Crystal River Nuclear Plant  
Docket No. 50-302  
Operating License No. DPR-72

Subject: Crystal River Unit 3 – Radiological Emergency Response Plan, Revision 30

Revision 30

**CR3 Radiological Emergency Response Plan, Rev. 30**  
**Description of Changes**  
**Page 1 of 8**

FIGURE 12.3  
TSC/OSC FLOOR PLAN  
SAMPLE

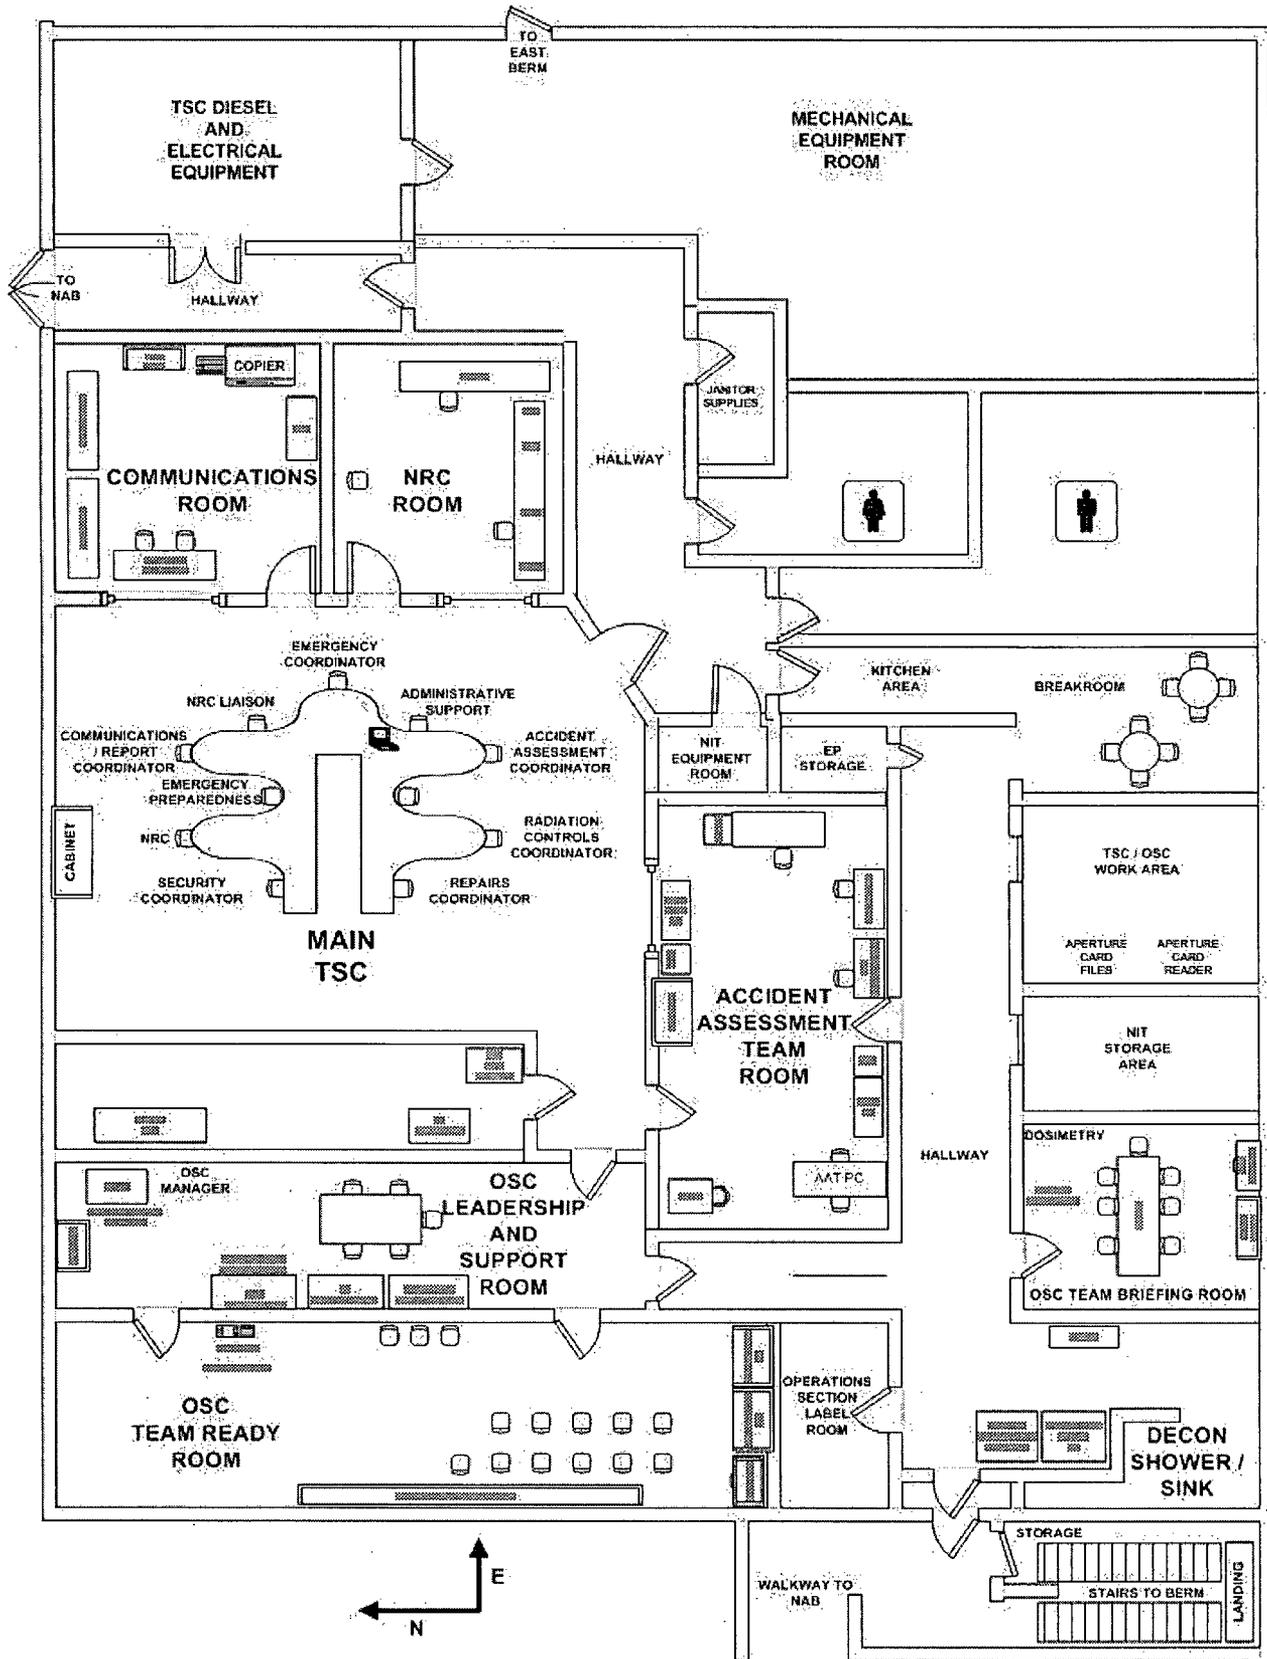
Page Numbers	Description of Changes and Comments/Rationale
	result of this change.
12-13	Figure 12.3. Replaced Figure to show the modified Work Area on the south side of the building which has had a partition wall added to it. The new space that this created is currently a storage area. The aperture card files and reader continue to be located within the Work Area. There is no decrease in effectiveness as a result of this change.
13-4	<p>Section 13.2.2; 7<sup>th</sup>, 8<sup>th</sup> and 9<sup>th</sup> paragraphs of section. Revised the 7<sup>th</sup> and 9<sup>th</sup> paragraphs to better reflect the current instructions as found in Emergency Plan Implementing Procedures CH-631, <i>Post-Accident Sampling and Analysis of Reactor Building Vent, and Reactor Building Atmosphere</i>, and CH-632, <i>Post-Accident Sampling and Analysis of Reactor Coolant, Decay Heat, and Reactor Building Sump</i>. The 8<sup>th</sup> paragraph is deleted in its entirety.</p> <p>As currently written, CH-631 provides guidance for collecting gas grab samples in the grab sampler WSSB-2 from Auxiliary Building (AB) vent, Reactor Building (RB) vent, and RB atmosphere; and particulate and iodine grab samples from RB and AB vents. Analyses are now performed off-site. Consequently, core damage correlations based on RCS samples would be performed using the off-site data. On-site core damage correlations continue to be available through containment high radiation monitoring, estimate of the time the core is uncovered, and RCS pressure/temperature relationship per EM-225.</p> <p>As currently written, CH-632 provides guidance for collecting gas grab samples in the grab sampler CASB-5 for Reactor Coolant System (RCS), Decay Heat (DH) , or RB Sump. Analyses are now performed off-site. Boron continues to be performed on-site by the borometer for RCS, DH, and RB Sump.</p> <p>These changes are primarily as a result of the selected removal and partial abandonment of Post-Accident Sampling System (PASS) components and functions which were performed under Engineering Change (EC) #49486. A 10 CFR 50.54(q) evaluation for the EC was conducted under REG AR# 318622 with a determination that there was no decrease in effectiveness. That determination is applied to this change to the RERP as well.</p> <p>There is no decrease in effectiveness as a result of these changes.</p>
